Application Site and Surroundings

Details of the Proposal

The proposal is for a residential led, mixed use town centre development, as defined in the 'hybrid' (mix of full and outline application elements) application description above.

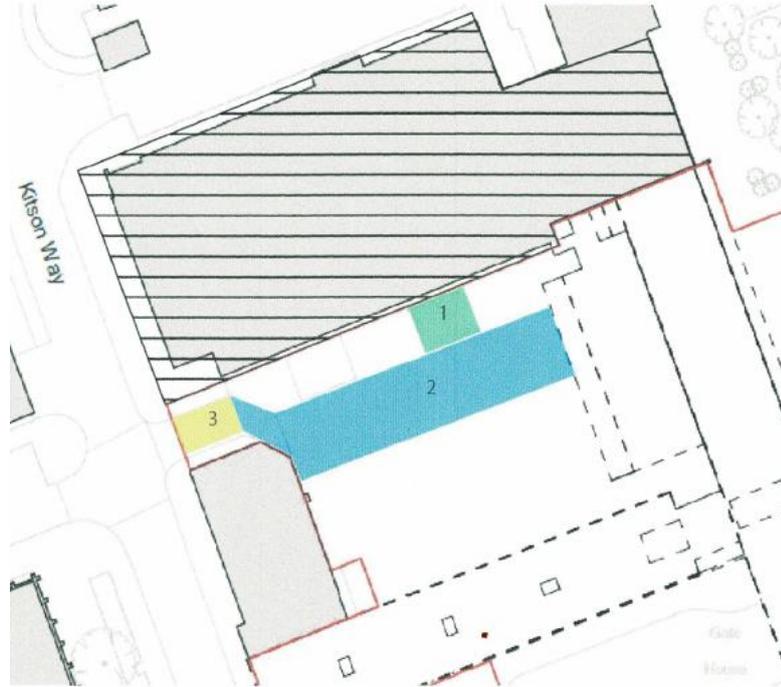
Access: Relating to the points above, there are a number of issues associated with the proposals for the north-west corner of the application site. Our clients' rights with respect to parking and access in this area lead us to believe that elements of the scheme in the vicinity of Block A are simply undeliverable. Had the application included full details of access (which the local planning authority suggested was the minimum feasible level of information for the application in its pre-application advice, notwithstanding its clear preference for a full application) it would be possible to determine the full extent of any conflict and therefore the deliverability of the proposals. As things stand, no one, including the highway authority, can determine whether what is proposed meets the necessary standards while observing certain contractual obligations, which are clear and cannot be overridden. While the planning

system operates independently of land ownership and rights there is little point determining the application as it stands when issues have been identified that may prevent the scheme being delivered as proposed. It would be a pointless exercise as amendments will only be required at a later date. Accordingly, we seek engagement with the local planning authority and the applicant on this matter without prejudice to the fact that it is clear that the application should not be approved in its current form for other fundamental reasons (set out elsewhere in this letter). The lack of consideration of our clients' properties is emphasised within the Design & Access Statement in which only one of the three that immediately flank the development site have been included in the surrounding context plan (see page 29). Within the Design & Access Statement we note the proposed widening of the access road immediately south of the former Odeon Cinema building and immediately north of Gate House West, which it appears the applicant proposes to widen and to use to serve Building A (see page 78). This widening will impact Gate House West significantly – the access and egress to the building for pedestrians will be severely compromised given that the main entrance is directly onto this road (which is proposed to be made wider by reducing the width of the already narrow pavement from which the building is accessed and egressed). The Principal Access and Circulation plan (drawing no. HTC-FLA -ZZ -ZZ -DR -A-05007) suggests that the existing access road will become the “main residential vehicular access & egress”. This, according to the drawing at least, is incorrect and misleading - it is the only residential vehicular access and egress. This means that it will serve all of the 578 units that have a car parking allocation. Given the size and specification of the access and the immediate highway network, and the absence of any detailed designs for the amendments proposed to the access, this is of real concern. There is nothing to indicate that what is proposed will meet the necessary technical and safety standards and therefore whether it will be acceptable to the highway authority. In any event, the widening of the road would be to the detriment of the current and future use of Gate House West. There also appears to have been little attention paid to the emergency escape routes in what will become a narrow, secluded alleyway from the adjoining former cinema site. In view of the necessary distinction between planning and land law matters, but while having regard to the fact that deliverability is a material consideration when determining planning applications (and in the interest of openness), we attach a letter from our clients detailing the ‘neighbourly matters’ issues relating to the north west corner of the site, and some related documents, so that you are able to make your own assessment of the deliverability of this area of the application scheme.

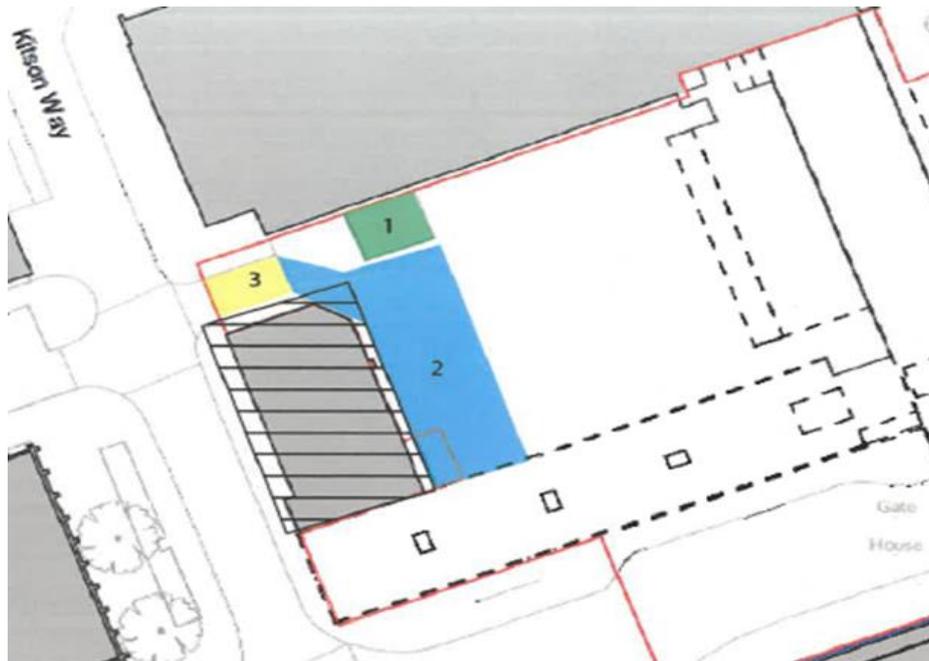
...Strong objections. As an immediate neighbour to the site of the proposed development (Former Odeon Cinema, hatched black in attached plan),.. the development will have a negative impact on our ability to continue to operate.

It is apparent that the applicant has presented the service courtyard as no longer in operation and that Blackraven Developments as tenants of the former Odeon Cinema no longer has rights over it. This is a false statement The Deed of Variation referenced clearly shows that the area that has been removed from the service courtyard is limited to a small parcel of land to the south of the cinema and a strip of land immediately behind Gate House West. For context, this variation was agreed in order for us to extend Gate House west in the early 1990's. Similarly if the applicant wishes to build on any of the service courtyard then a Deed of Variation will need to be agreed with the tenant of the former Odeon cinema, Blackraven Developments Ltd. No such agreement exists and no approach has been made by the applicant to enter discussions into making any such agreement. Therefore, as it stands, this issue alone will mean that the application submitted is not deliverable. It should be noted that the issue of the service courtyard has been raised in multiple objections to the scheme but ignored by the applicant. (copy of Deed provided)
